Safety Defect and Noncompliance Report Guide for Vehicles  
PART 573 Defect and Noncompliance Responsibility and Reports<sup>1</sup>

Furnish the manufacturer's identification code for this recall (if applicable): RCL-08-004

Make(s): DUCA71 Model Years Involved: 2008 Model(s): DESMOSEDICI RR

**Recall Bulletin RCL-08-004 D16RR Fuel Tank Drain & Breather Hoses**

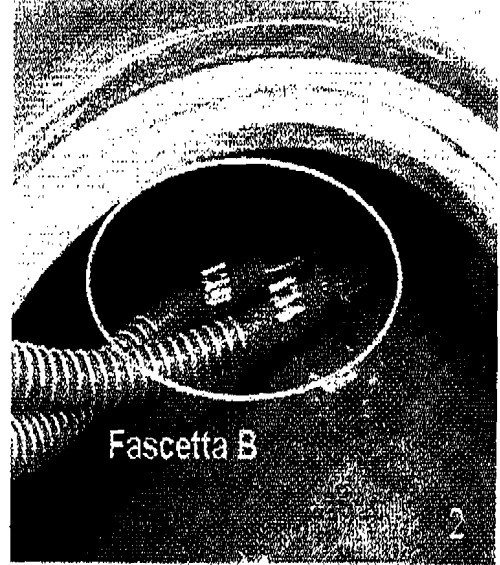
Ducati Motor Holding S.P.A. has determined that the position of the hose clamps on the fuel filler drain hose and fuel breather hose is incorrect, and that the 2 hoses may have become damaged. This can result in a possible fuel leak.

Two hoses, part no. 59011581A, were replaced. Two crimp style hose clamps were superseded by hose clamps part no. 74141001A.

Ducati North America, Inc. will auto-ship to all authorized Ducati dealers initial quantity 2 hoses, part no. 59011581A, and an initial quantity 2 hose clamps, part no. 74141001A. Additional quantities may be ordered as required.

- Install the new drain and breather hoses (part no. 59011581A) to fuel tank and filler flange and reverse the hose clamp positions; hose clamps A (Phillips screw style clamps) (picture 1) removed from the filler flange shall be installed to the tank while hose clamps B (picture 2) shall be replaced with the new ones (part no. 74141001A) and installed to the filler flange.
